## **Packet Guide**

BAR 21-07-01

854 Locust Avenue, Tax Parcel 510092000

Project: Garage construction

**2** NORTHWEST ELEVATION  
SCALE: 3/32" = 1'-0"

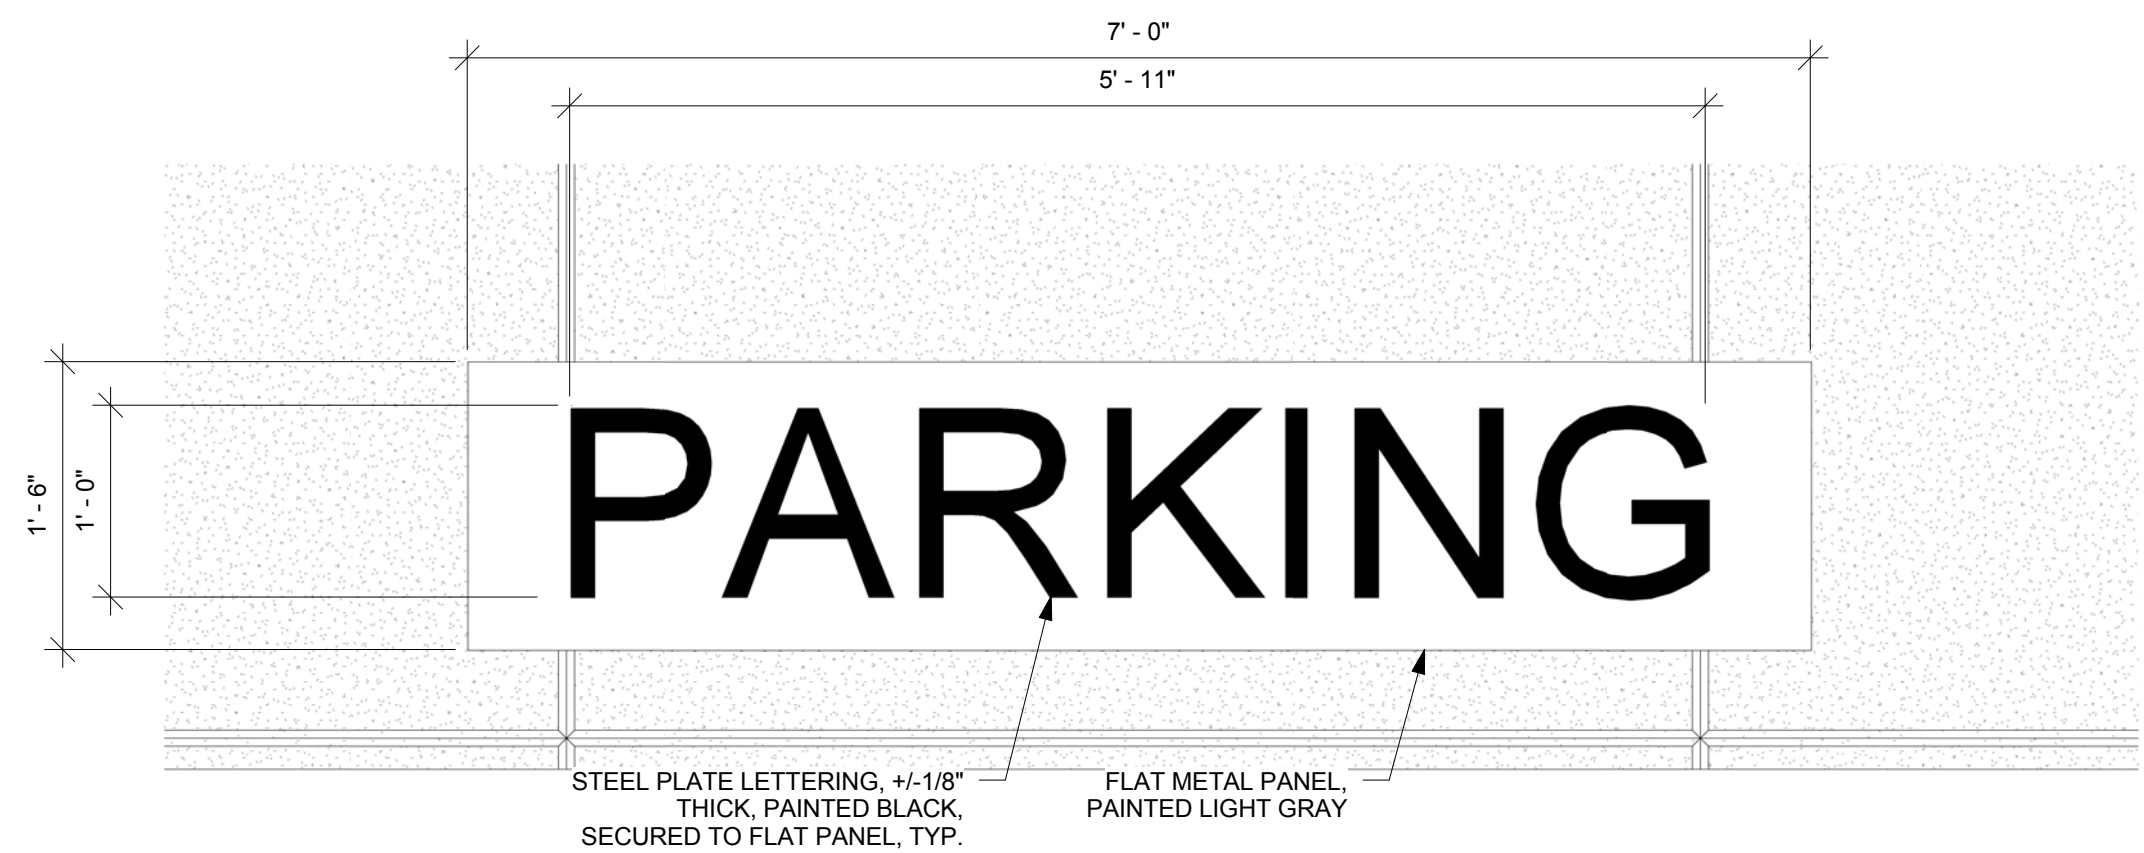
The areas to be repaired are all stucco walls shown on the elevations on sheets A-200 and A-201-- see the key in the lower, righthand corner. (Note: the clouded area on these sheets are not relevant. They are from modifications made in 2017, and not related to the stucco repair.)

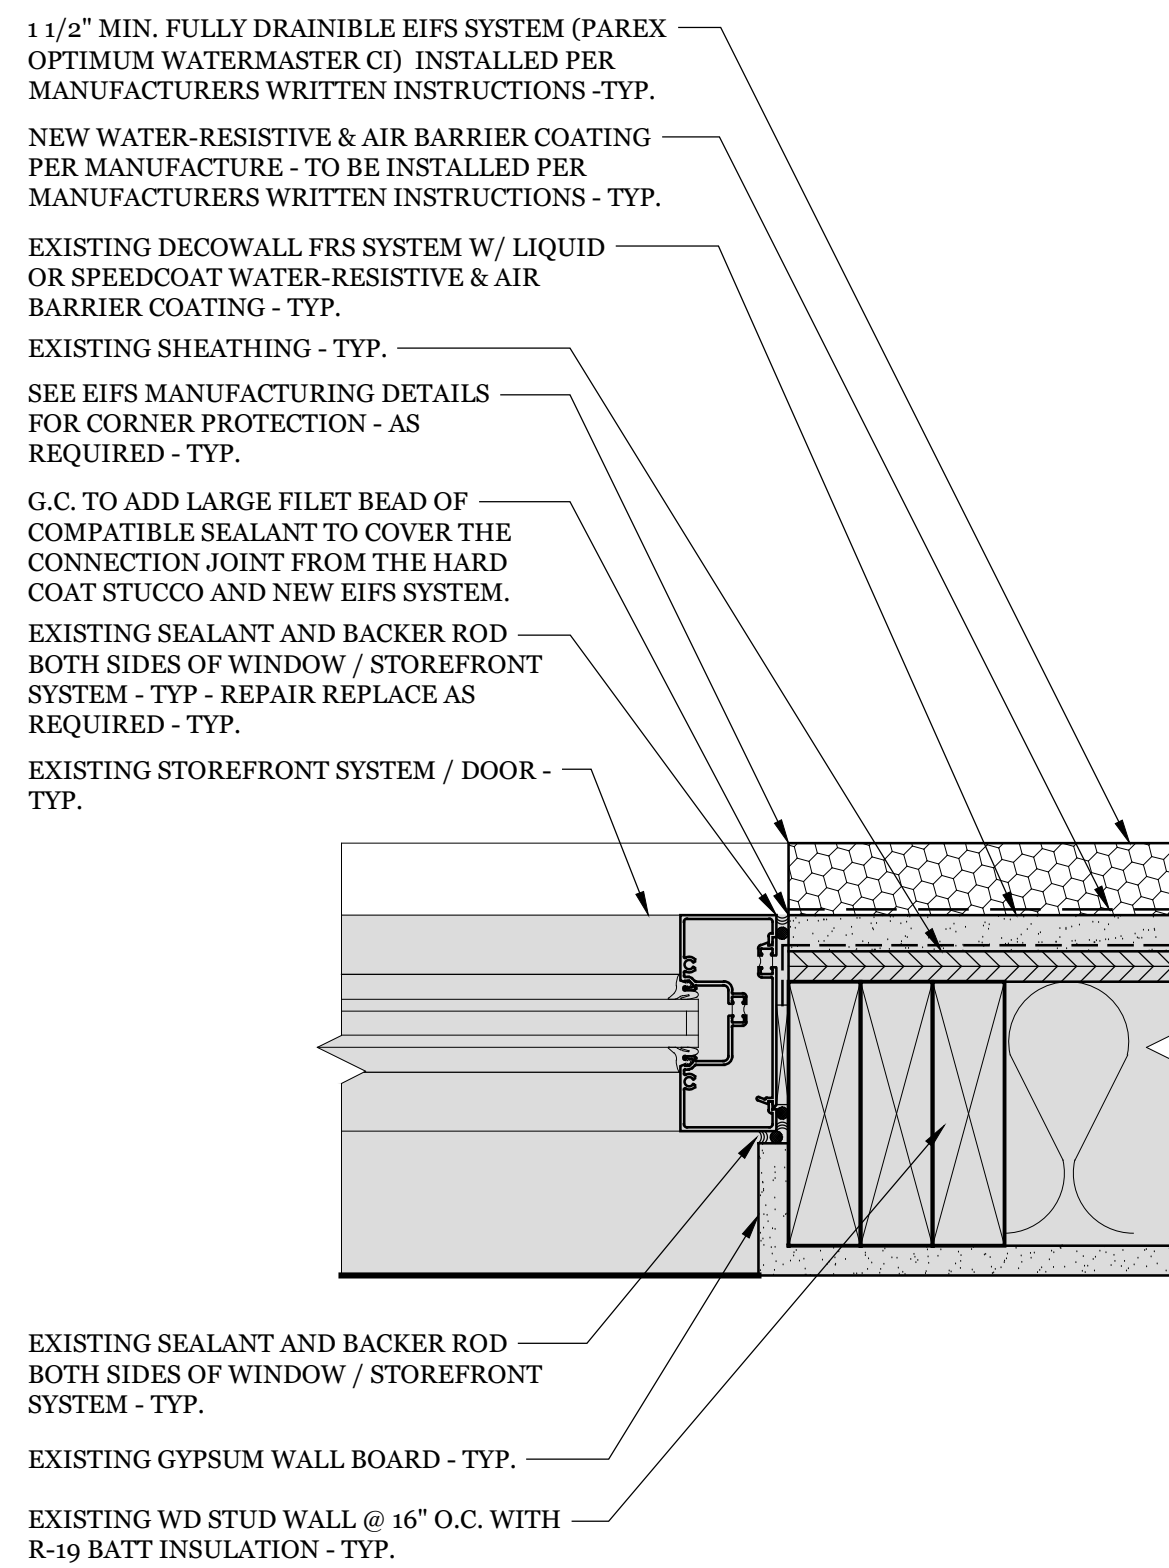
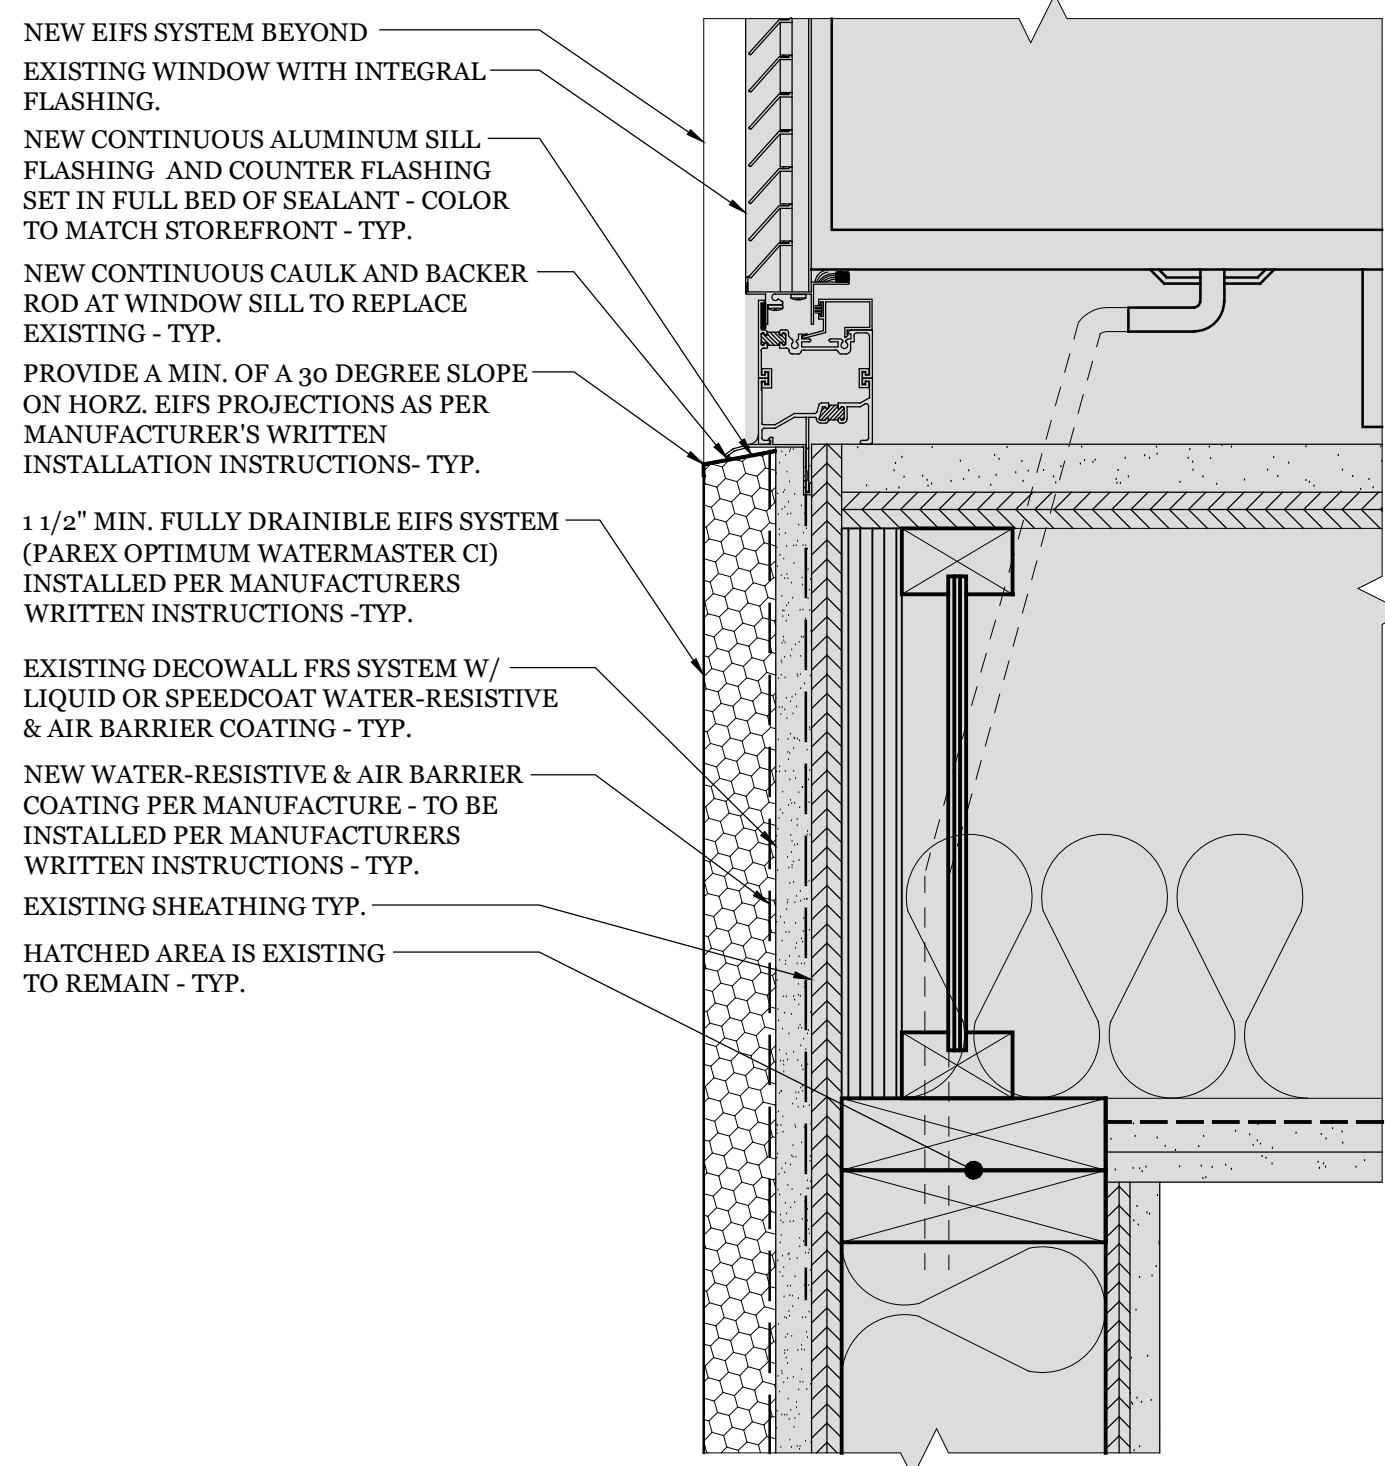
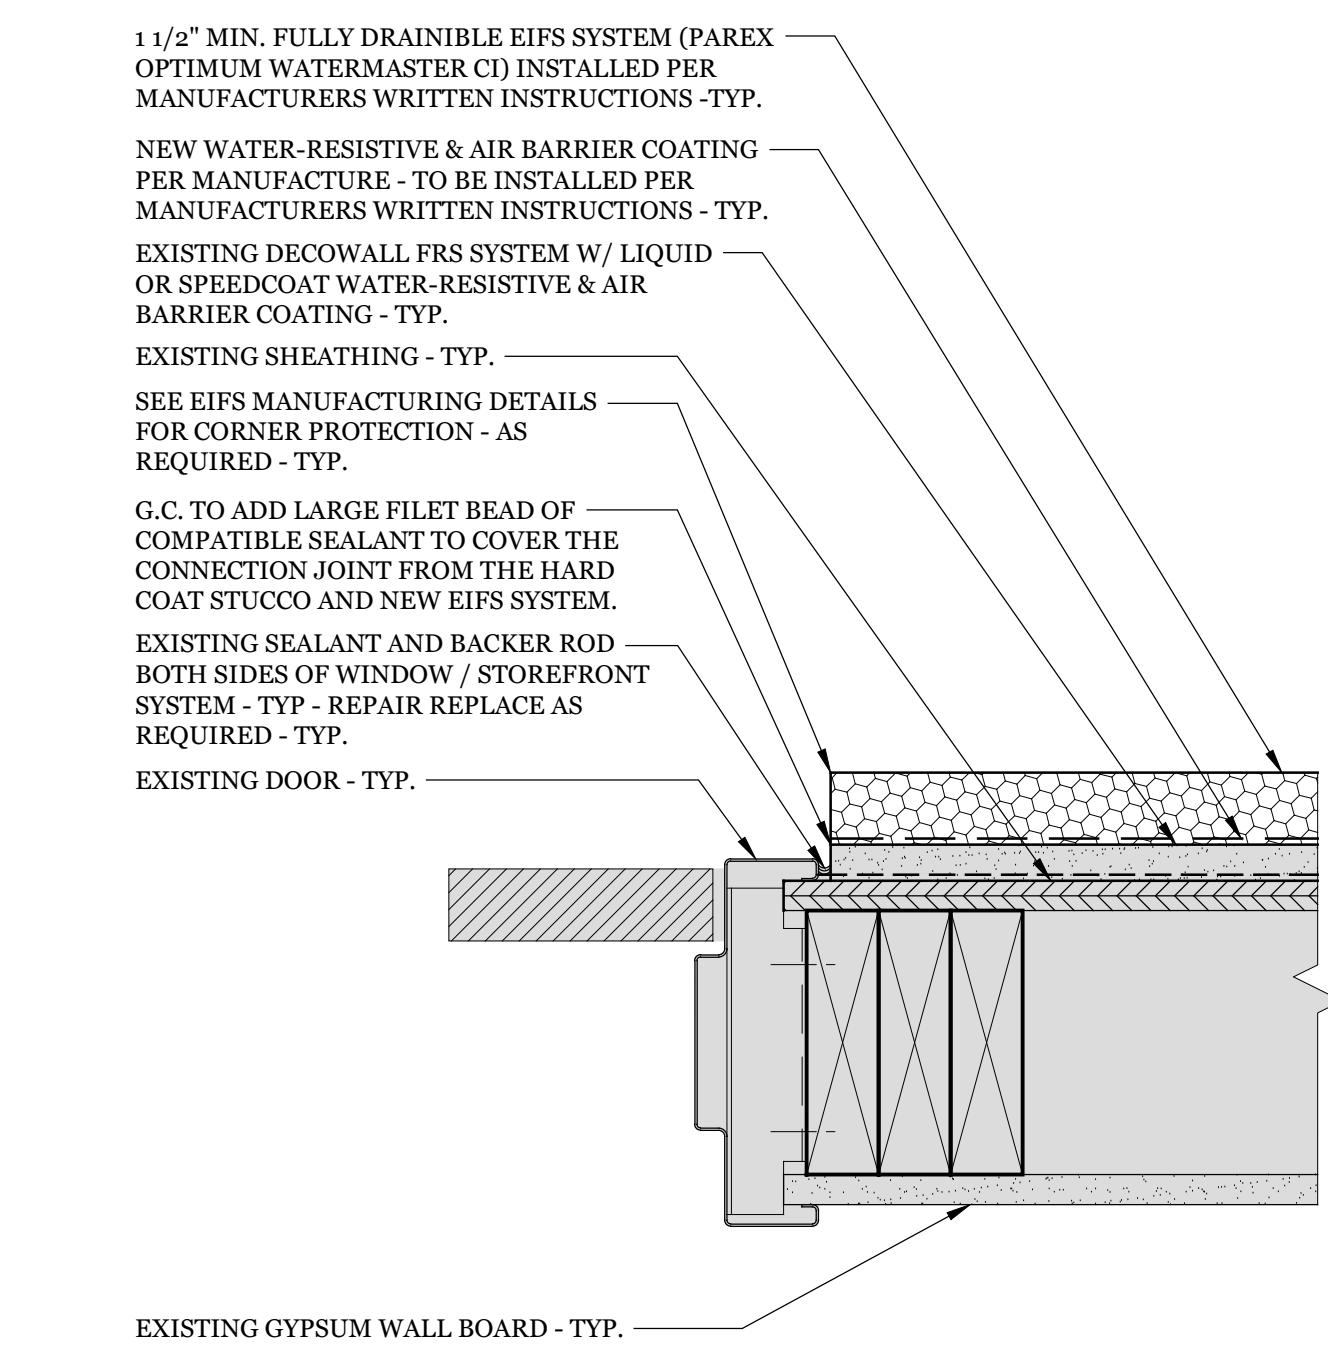
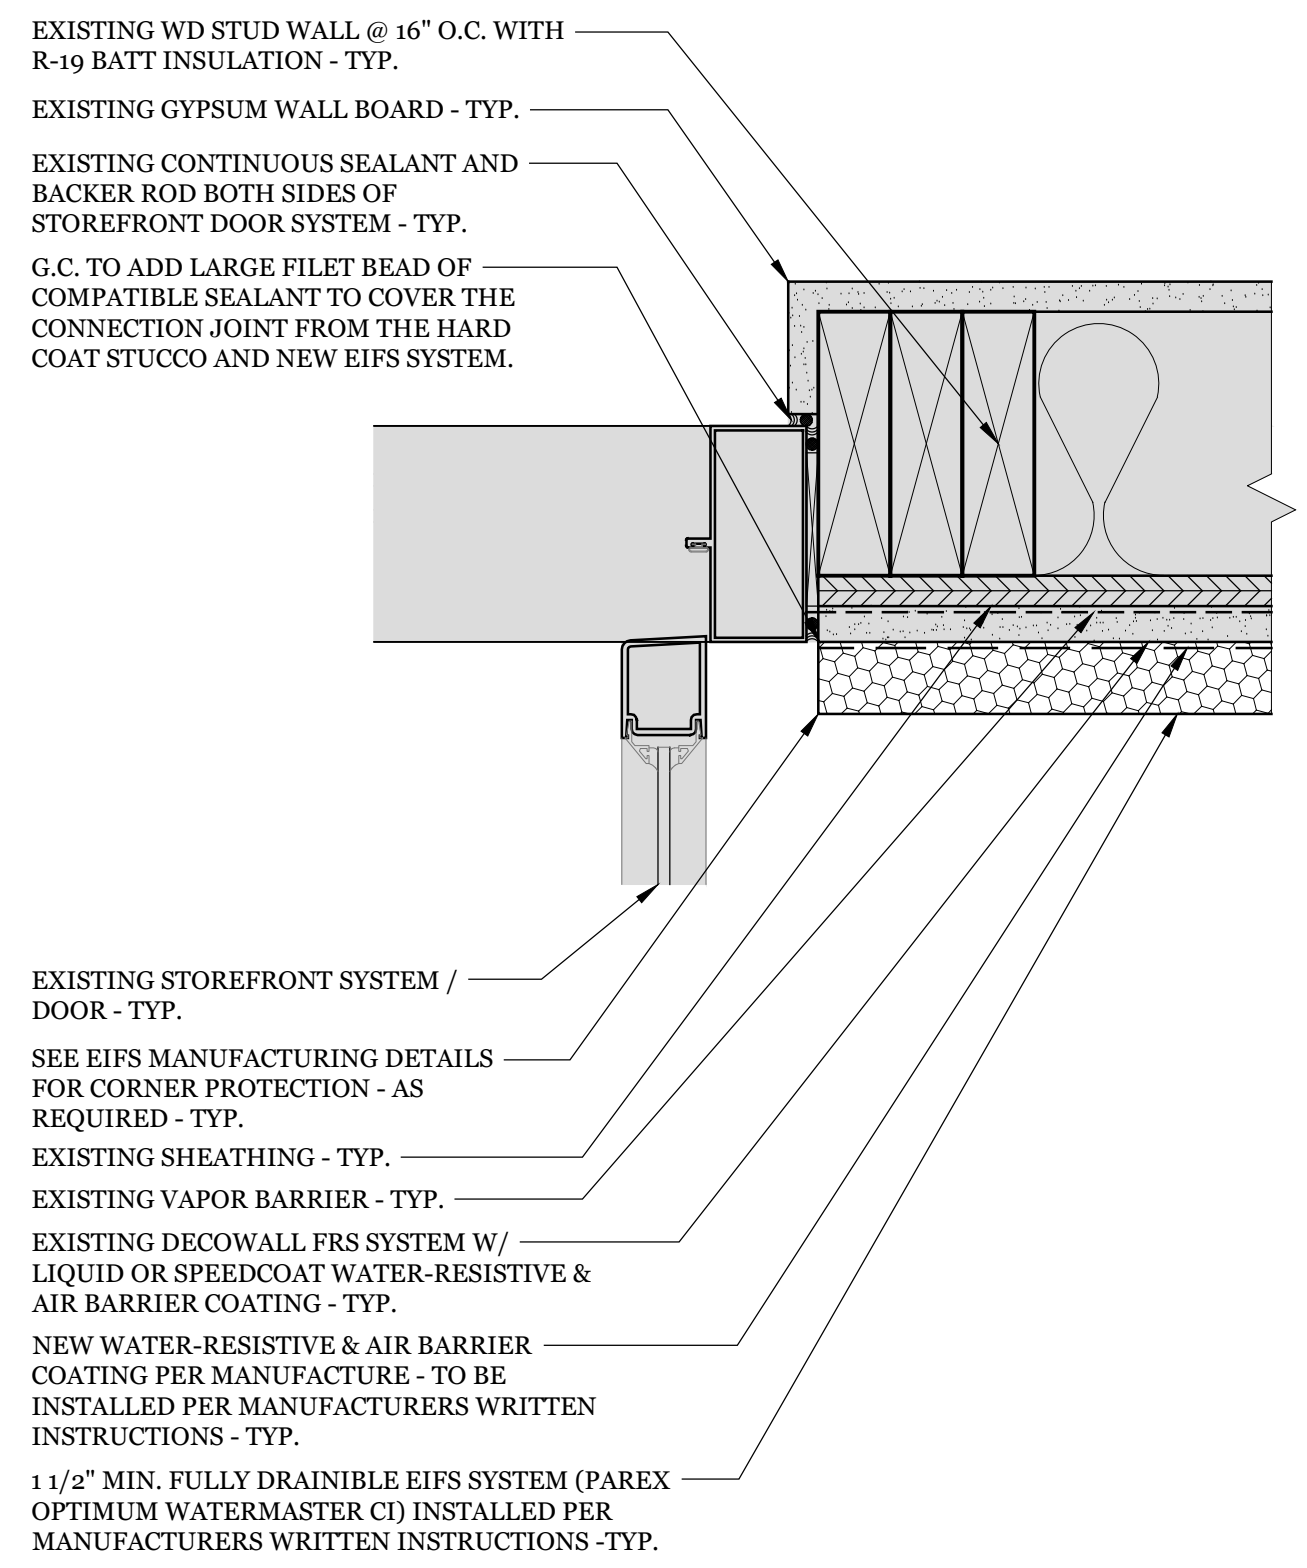
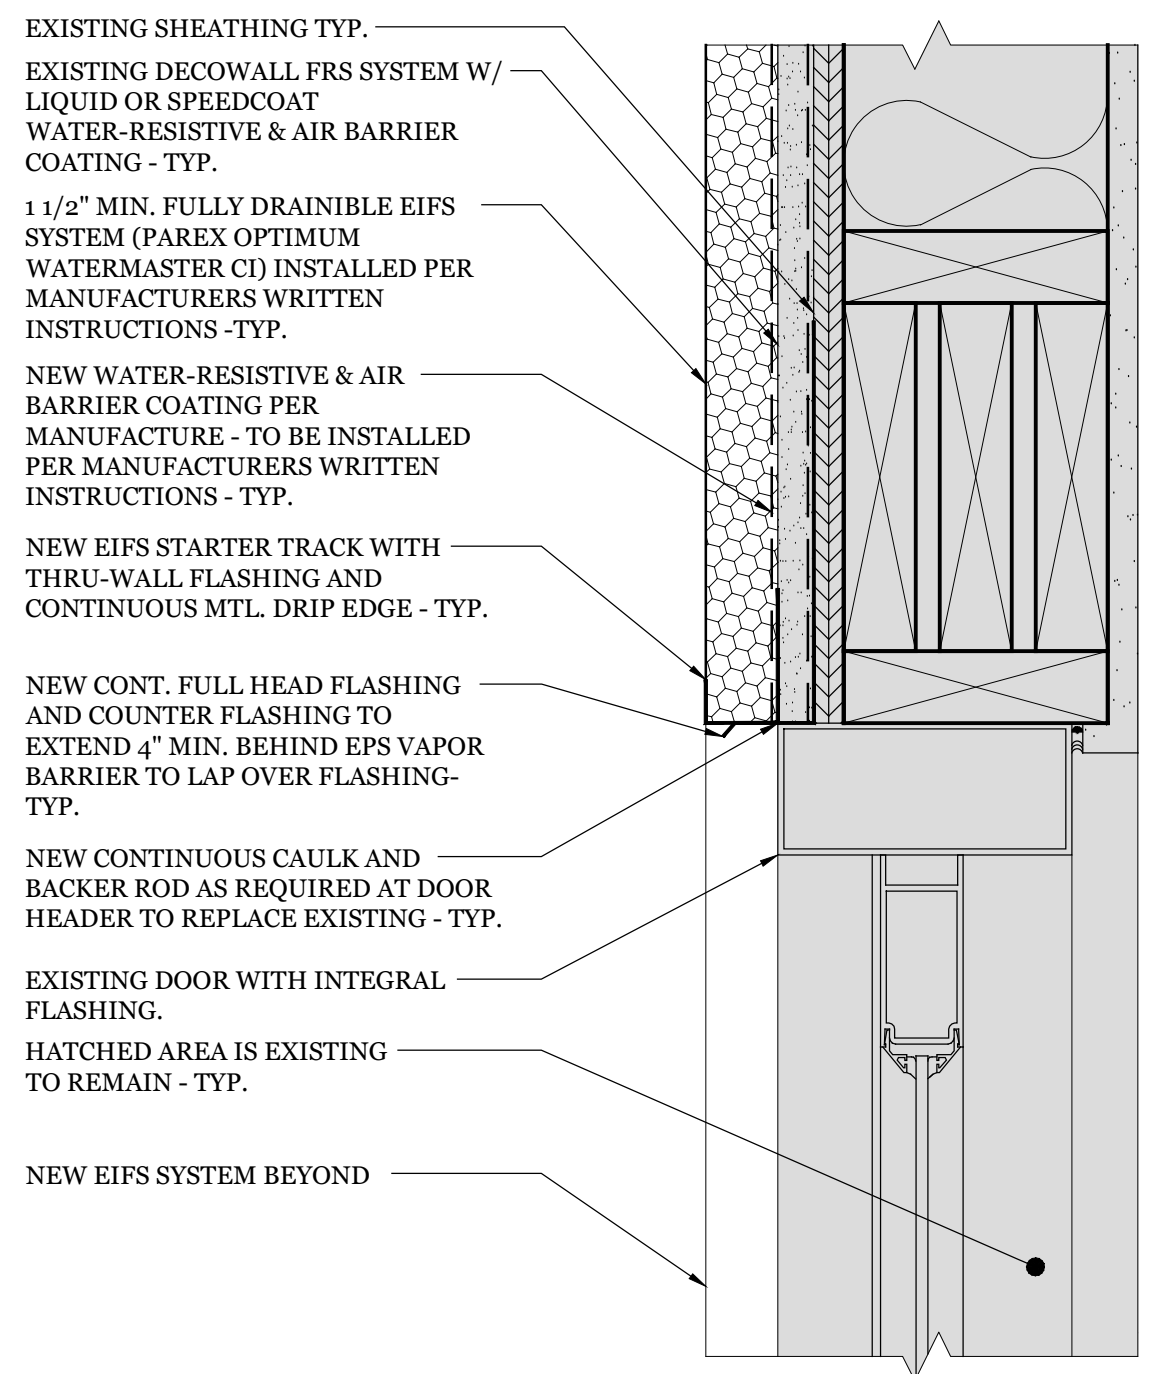
The proposed repairs will apply a Parex EIFS system over the existing hard coat stucco. The primary details are shown on sheet A-455, which references to the existing hard coat stucco system (Decoplast Decowall FRS) and details how the Parex EIFS system will be installed (the water resistive and air barrier coating installed over the existing stucco). A-455 also illustrates the details at the various components—door and window trim and sills, roof parapet, etc.

Aside from the material and methods proposed for the repairs, the repairs will result in a slight reveal at the perimeter of the existing windows, doors, and vents. As built, the stucco is flush with these components—see the images below. This modification is detailed on Sheet A-455. This new detail will be consistent on the building—and, in fact, be similar to the reveal condition at the brick wall segments. Staff suggests this is an acceptable detail modification.
